**Planning Department
Transportation Development Services**

**Re: Blue Linx Warehouse Adaptive Re-Use Project
1820 Bellamah Ave., NW
Traffic Circulation Layout
Engineer's/Architect's Stamp dated 5-26-15 (J13-D101)**

Project no. 1407
sheet
A-1.2
5 of 34
5-26-15

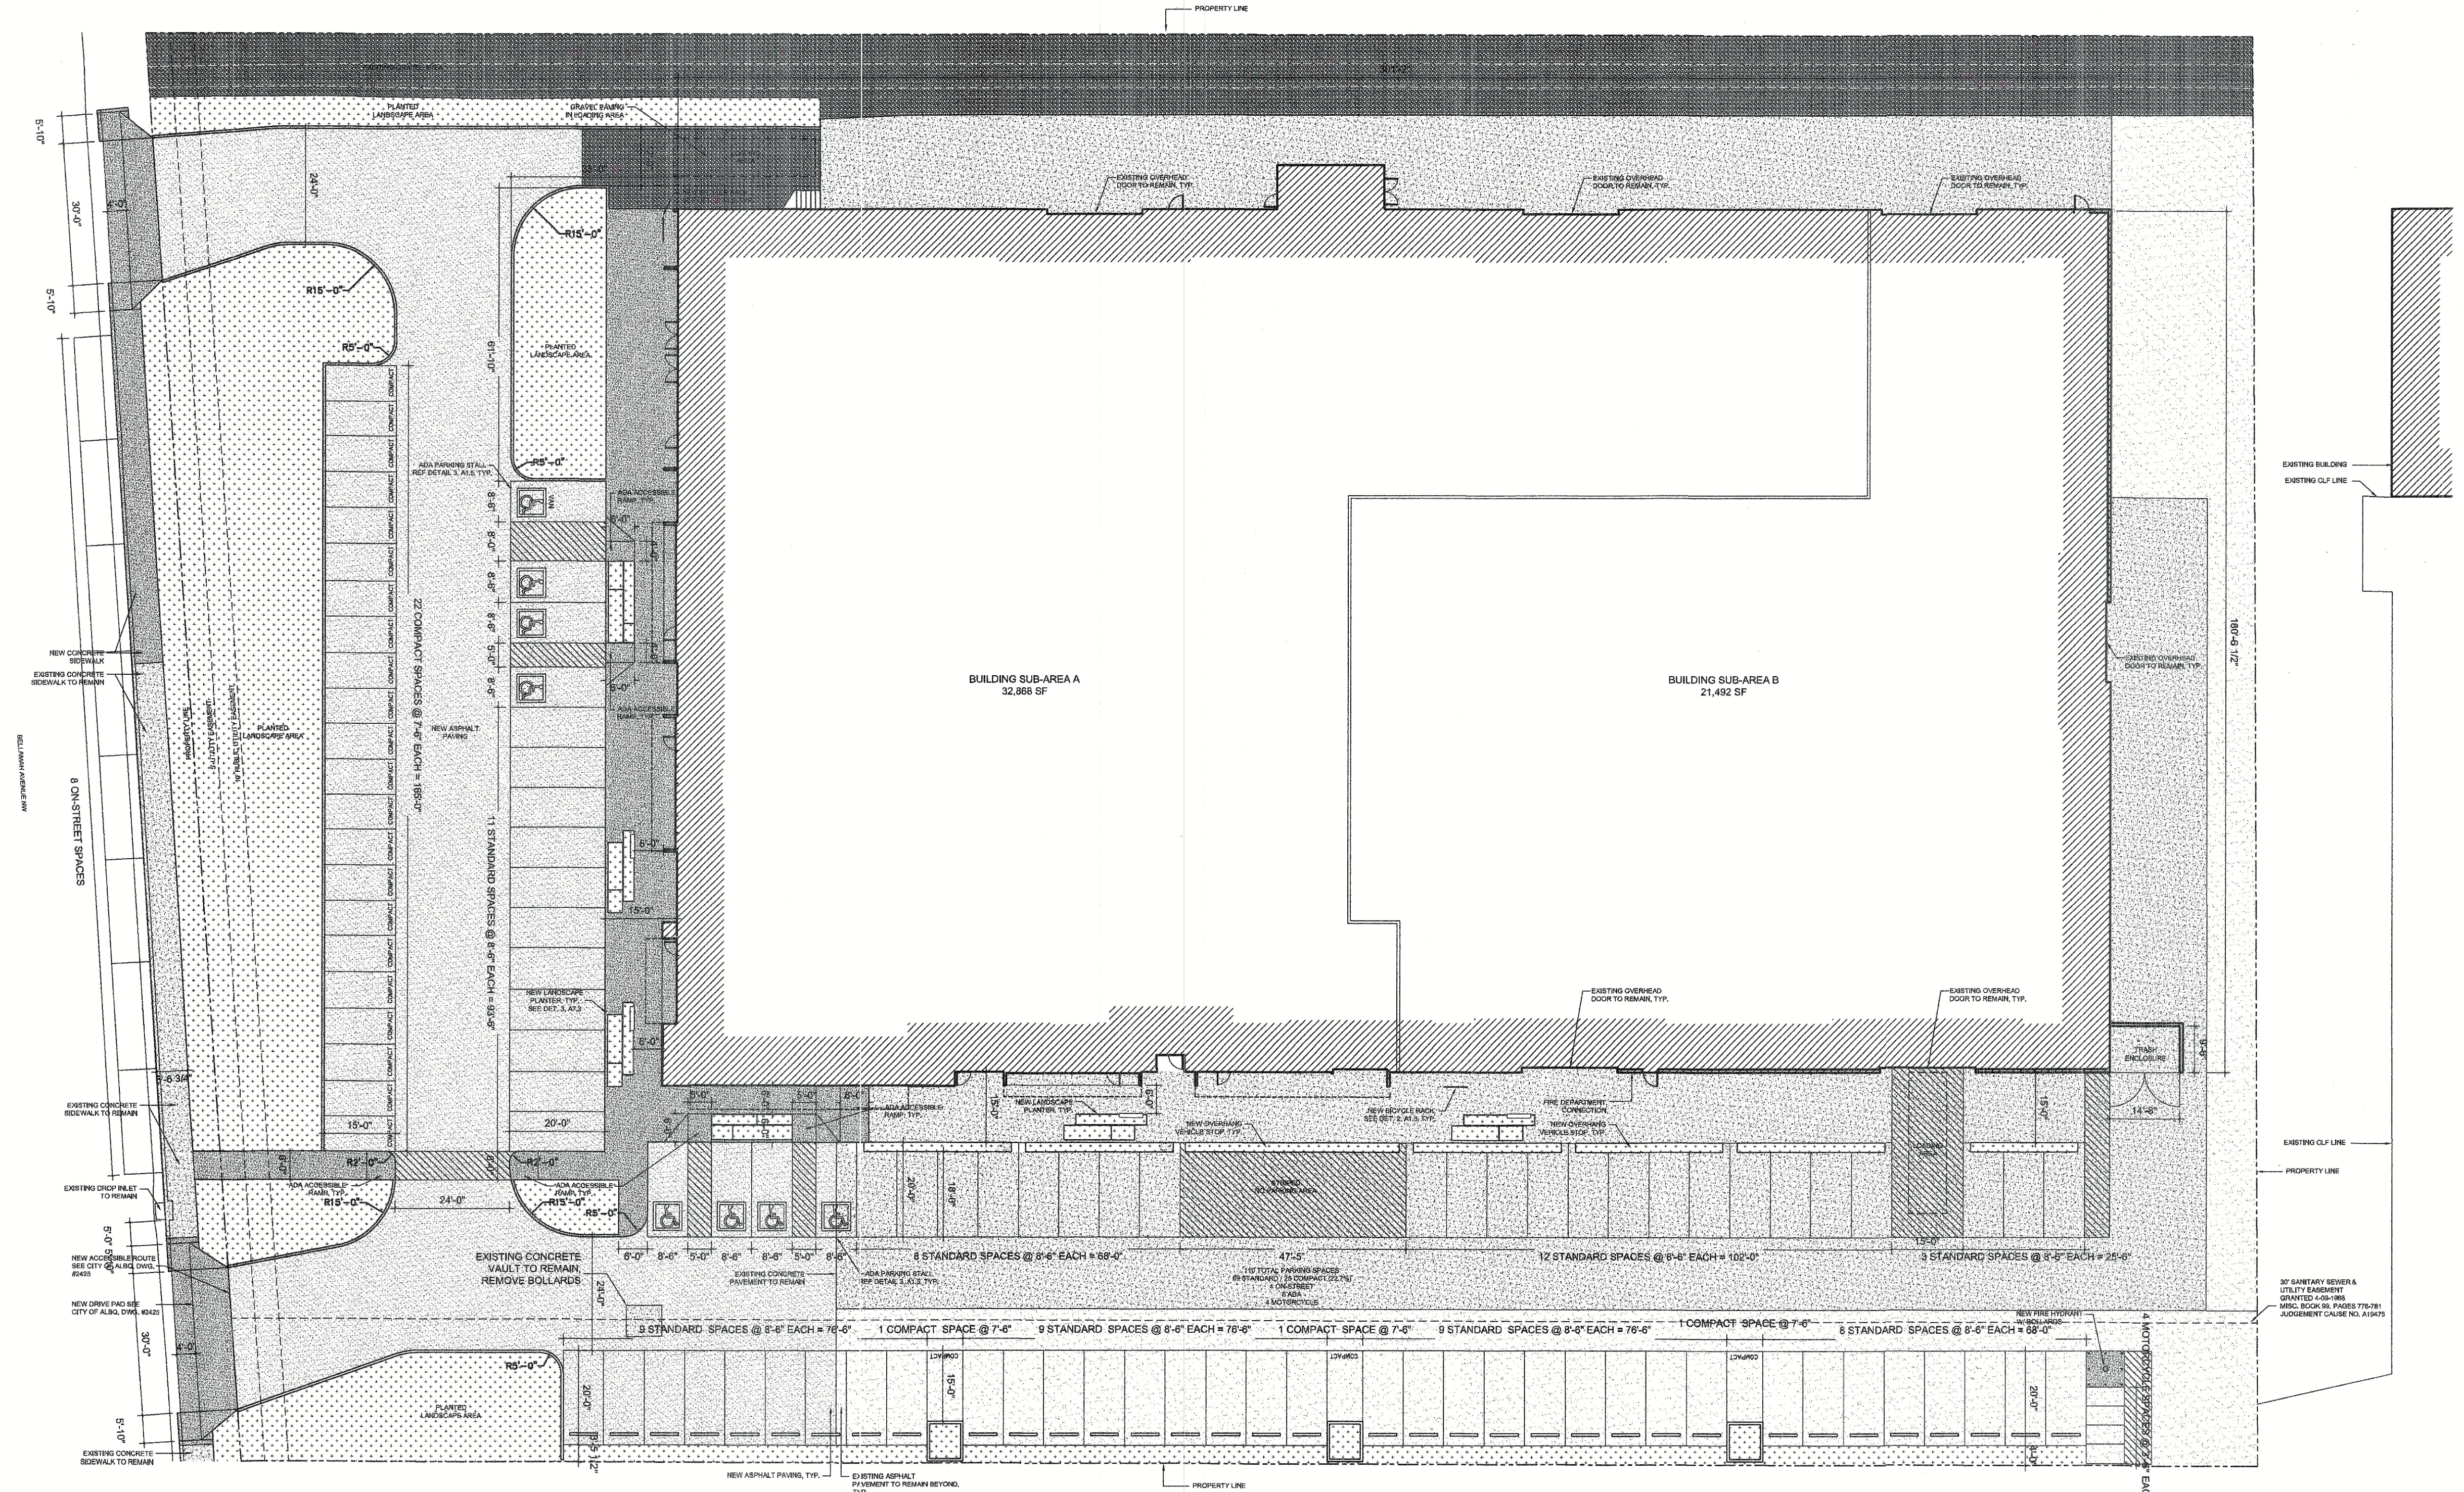
1. Identify the right of way width, medians, curb cuts, and street widths on Bellemah Ave., 18th St. and 19th St.
2. Please detail "Overhang Vehicle Stops" on west side of building and call out Turn Down Edge bumper stops on north side of building.

3. Please refer to the Fire Marshall regarding parking space in front of Fire Department Connection point, stripping might be required.
4. The ADA accessible sign must have the required language per 66-7-352.4C NMSA 1978 **"Violators Are Subject to a Fine and/or Towing."**

5. The ADA access aisle shall have the words **"NO PARKING"** in capital letters, each of which shall be at least one foot high and at least two inches wide, placed at the rear of the parking space so as to be close to where an adjacent vehicle's rear tire would be placed. (66-1-4.1.B NMSA 1978)

6. Please detail and dimension ADA ramps from handicap parking to building entrances on north and west sides of the building.
7. Provide a min 6" or max 8" high concrete barrier curb or other acceptable barrier between landscaping and parking areas and/or drive aisles. Please call out barrier curb, turndown edge and overhang wheel stop locations.

8. Design delivery vehicle route needs to be shown.
9. Service vehicle and/or refuse vehicle maneuvering must be contained on-site; provide a copy of refuse approval.

10. Please provide a sight distance exhibit (see the *Development Process Manual, Chapter 23, Section 3, Part D.5 Intersection Sight Distance*). Please show this detail for both the entrances on Bellamah Ave.

11. Please add the following note to the clear sight triangle: "Landscaping and signage will not interfere with clear sight requirements. Therefore, signs, walls, trees, and shrubbery between 3 and 8 feet tall (as measured from the gutter pan) will not be acceptable in this area."
12. Please include two copies of the traffic circulation layout at the next submittal.
